# UNITED STATES PATENT AND TRADEMARK OFFICE

APPLICATION NO.	FILING DATE	FIRST NAMED INVENTOR	ATTORNEY DOCKET NO.	CONFIRMATION NO.
10/583,307	03/06/2007	Kiyoshi Sadakata	KAM 22.600 (100799-00133)	5093
26304 7590 05/28/2009 KATTEN MUCHIN ROSENMAN LLP 575 MADISON AVENUE NEW YORK, NY 10022-2585			EXAMINER FREEDMAN, LAURA	
			ART UNIT 3616	PAPER NUMBER
			MAIL DATE 05/28/2009	DELIVERY MODE PAPER

<b>Office Action Summary</b>	<b>Application No.</b> 10/583,307	<b>Applicant(s)</b> SADAKATA, KIYOSHI	
	<b>Examiner</b> Laura Freedman	<b>Art Unit</b> 3616

## **DETAILED ACTION**

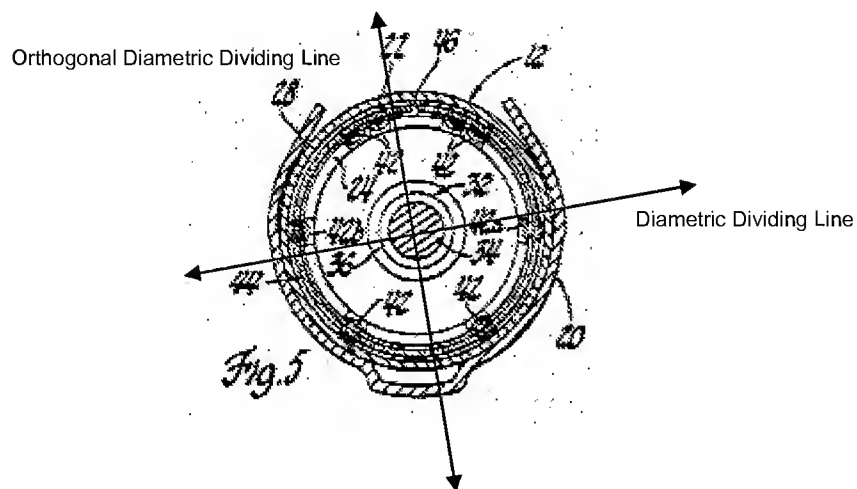
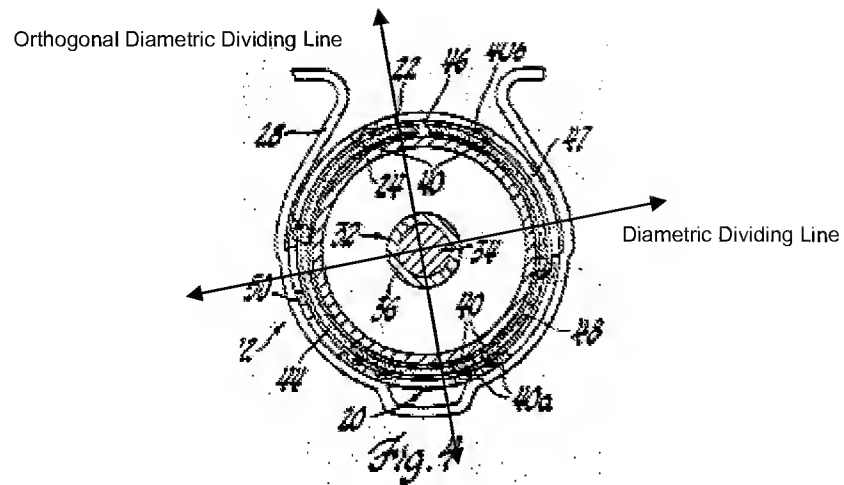
- In the case where it is assumed that the overlap portion is divided into two in a diametric direction (for example, as indicated by diametric dividing line in marked-up figures below), each of the engaging portions exists in a state biased towards a position away from the divided section (for example, including #40, 42, 40a, 40b, 42a, 42b located away from diametric dividing line)

- An interval in relation to the circumferential direction between engaging portions that exist astride an imaginary line orthogonal to the direction of division (as indicated by orthogonal diametric dividing line in marked-up figures below) is made smaller than an interval in relation to the circumferential direction between engaging portions that exist astride an imaginary line in the direction of division (for example, an interval between #40, 42 located on the upper portion of #22, 24 and to the left of the orthogonal diametric dividing line in figures 4, 5 and the orthogonal diametric dividing line, is made smaller than an interval between #40, 42 located on the left side of #22, 24 and above diametric dividing line in figures 4, 5 and the diametric dividing line, as can be seen in marked-up drawings below)

closest to the orthogonal diametric dividing line) is made to be greater than the number of the other engaging portions (including bottom of column 3-top of column 4)

Examiner notes that lines drawn in the marked-up figures below may not intersect exactly at the center point of the steering column components, and may not be precisely orthogonal to each other, but have been drawn to the best of her ability, and are merely exemplary in nature.
